VW Lupo **All vehicles with manual air** **conditioning up to model year 02.2000**

Air conditioning occasionally does not work

Bulletin

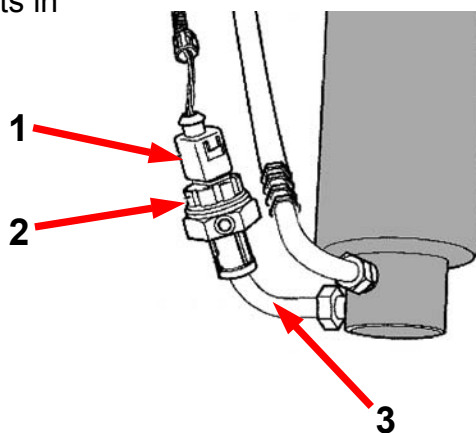
If there are complaints about the above-mentioned fault, the cause could be a defective pressure switch. Under certain operating conditions of the air conditioning system, the defective pressure switch switches the system off occasionally. In this case, the pressure switch, in the high-pressure circuit, must be replaced. The pressure switch can be removed without having to recover the refrigerant.

- Remove the bumper trim. The pressure switch, on the filter-dryer, is located on the right, behind the trim.
- Remove the plug connection (1).
- Hold the refrigerant line (3) steady when unscrewing the pressure switch (2).
- Replace the sealing ring, and screw the new pressure switch (Behr-Hella no.: 6ZL 351 028-221) on tight to a torque of 8 Nm.
- Refit removed parts in reverse order.
